DEPARTMENT'S ASSESSMENT REPORT

Valley of the Winds Wind Farm (SSD-10461) Assessment Report | 41

VIEWPOINT 017

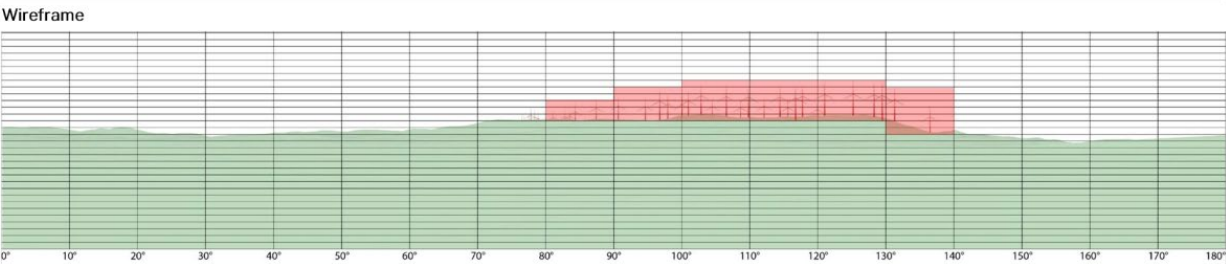
A 180 degree photo visually recedes the turbines in the centre of the photo, which is why 60 degree photos are also supplied to the landowner – this is more what a real person will “see”. This study from 2019 reinforces the lack behind panoramic photomontages.

Whilst we understand your scope is not to assess the Guidelines themselves, utilizing the 2024 guidelines for visual magnitude and multiple turbines for a project that is under the 2016 guidelines, is detrimental to the community and non-associated neighbours impacted by this project.

The 2016 guidelines required a subjective decision by a real person, the 2024 version removes this - it comes down purely to numbers of grids. Numbers don't always reflect real experience.

Using the 2024 guidelines should not be permitted and the Department should re-assess the visual impacts as per the previously established guidelines.

Photomontage 01

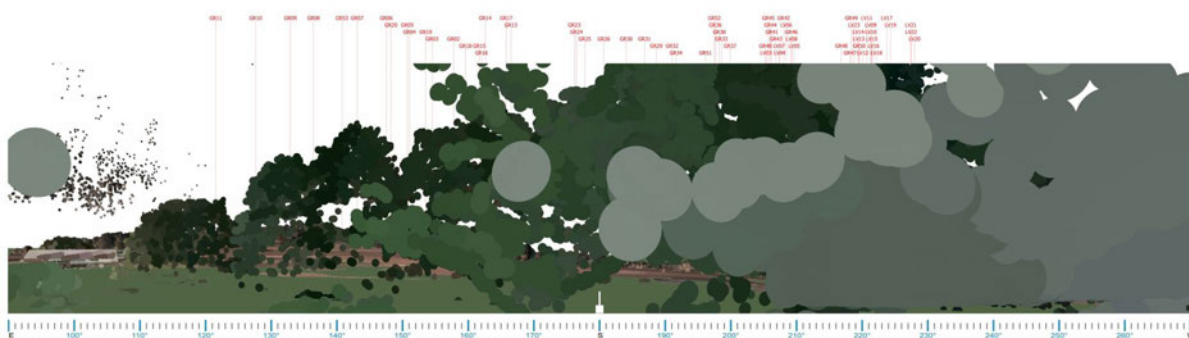
The 2024 guidelines will utilize the 180 degree view (at top) where the turbines are not dominant, unlike the 60 degree view in the 2nd photo.

The Applicant will almost always ensure there is some existing vegetation blocking the view of some turbines from the location selected for an assessment photo. However, a home and

Figure 4: Highest predicted noise level contours for GE 6.0-164, dB LAeq

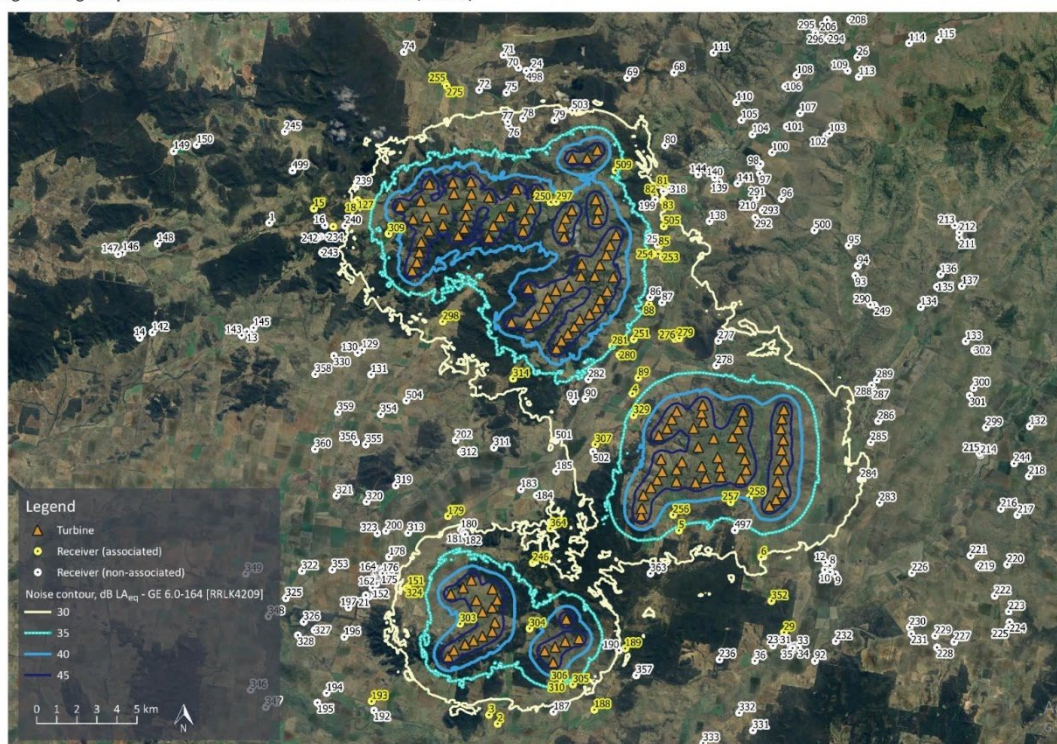
Because of the possibility of nuisance or potential harm to those in non associated dwellings, we request that B16 (a) include the following:

B16(a) undertake noise monitoring to determine whether the development is complying with the relevant conditions of this consent by installing noise monitoring equipment at willing non-associated residences within the noise contours within the 30dB lines. Equipment is to operate 24/7 (when turbines are operational). Monitoring equipment needs to be positioned*
